Submission of Further Information

Proposed Temporary Warehouse (excluding Dangerous Goods Godown) with Ancillary Office and associated Filling of Land for a Period of 3 Years

Lots 29 (Part), 33 (Part) and 35 (Part) in D.D. 111

(Application No.: A/YL-PH/1077)

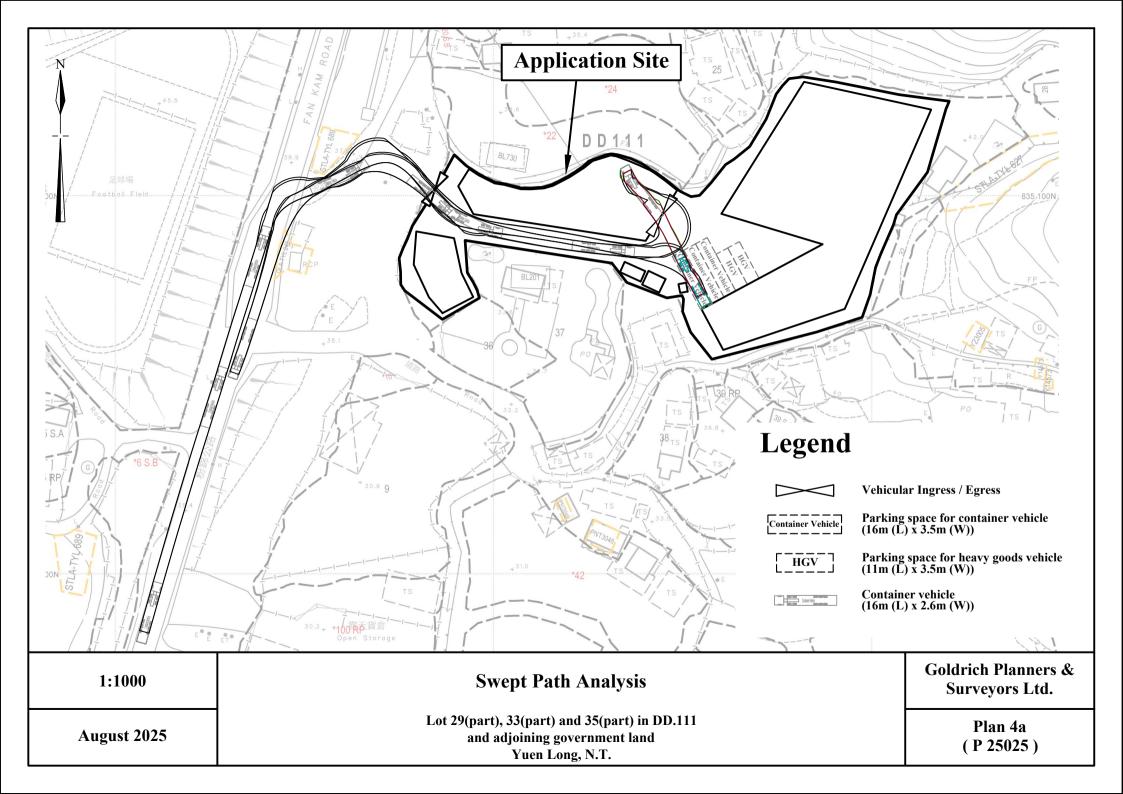
Comments	Responses				
2.	According to our record, there are existing streamcourse/channel on government land within the application site that may also serve the adjacent land. There is a potential increase flooding risk to the area if the government land and the streamcourse/channel are disturbed or affected by the operation of the applicant.	The existing streamcourse/channel on government land within the application site will be preserved and maintained. The operation of the applicant will not disturb the existing streamcourse/channel. As the existing streamcourse/channel on government land has all the time been receiving surface runoff from the subject site, there will not be any increase or change in the waterflow.

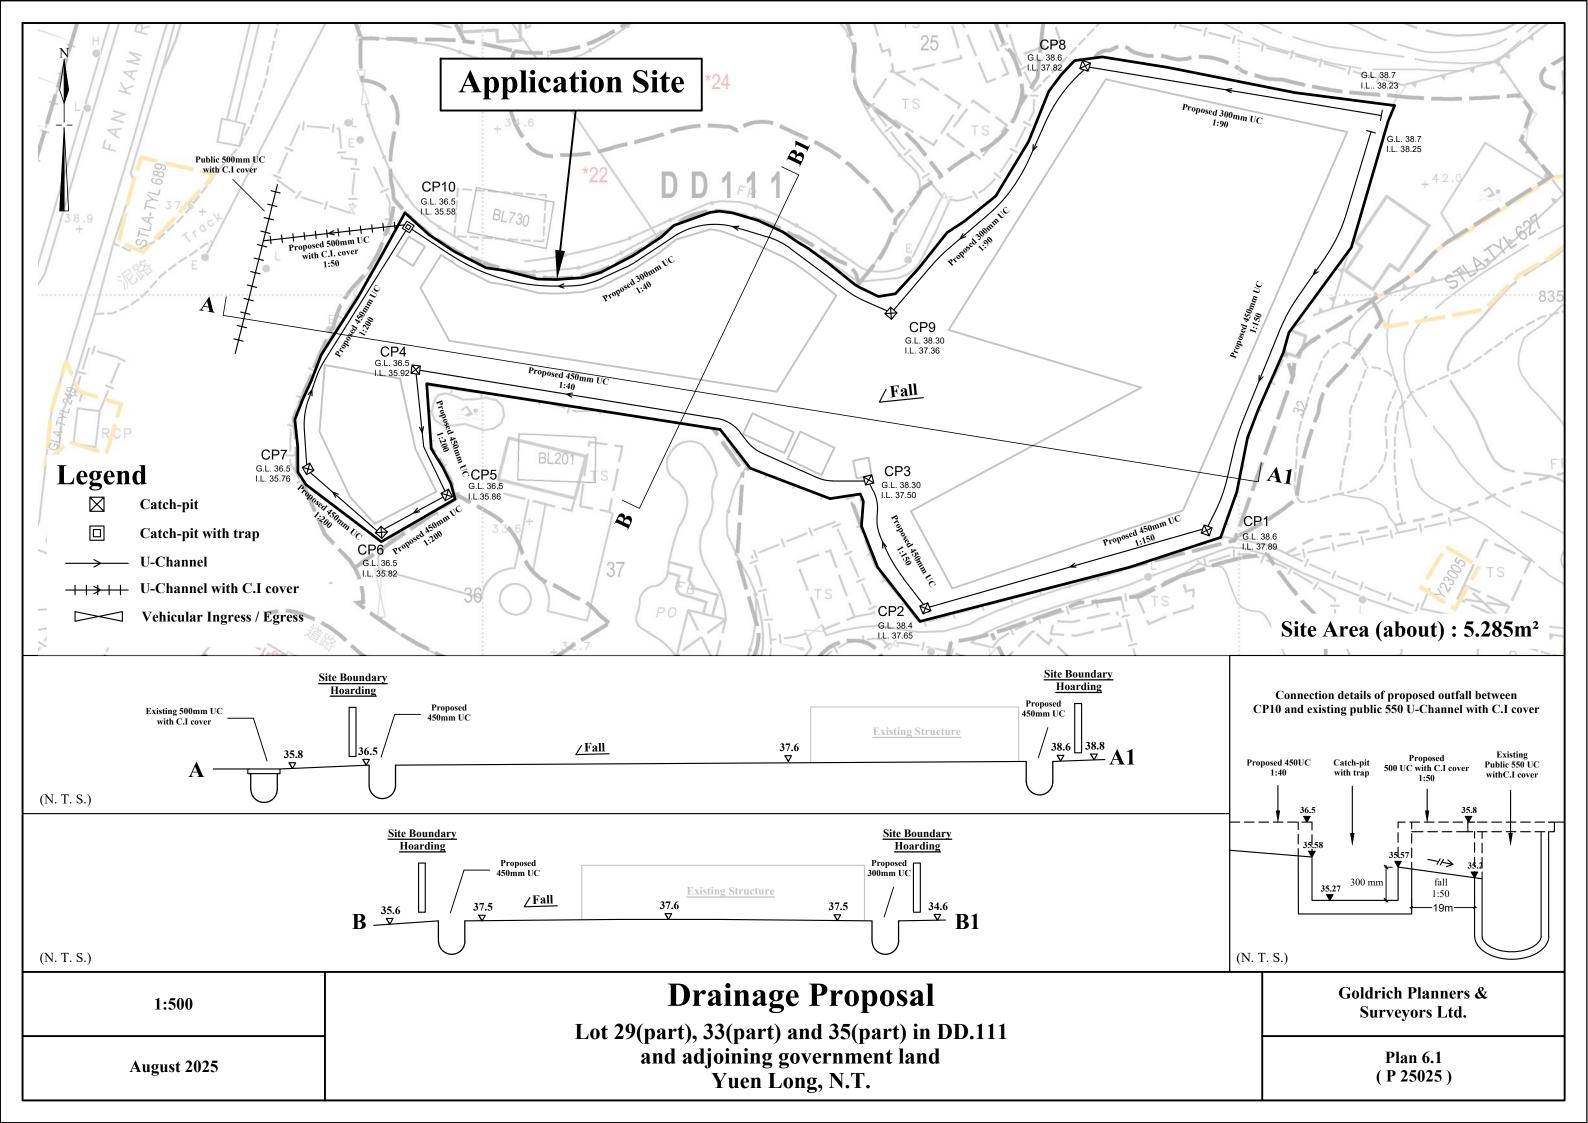
3.	We are unable to provide comment on drainage aspect of the application at this stage. Comment on drainage aspect will be provided when the drainage proposal as mentioned in paragraph 17 of the planning statement is received.	Please refer to attached drainage proposal for details.
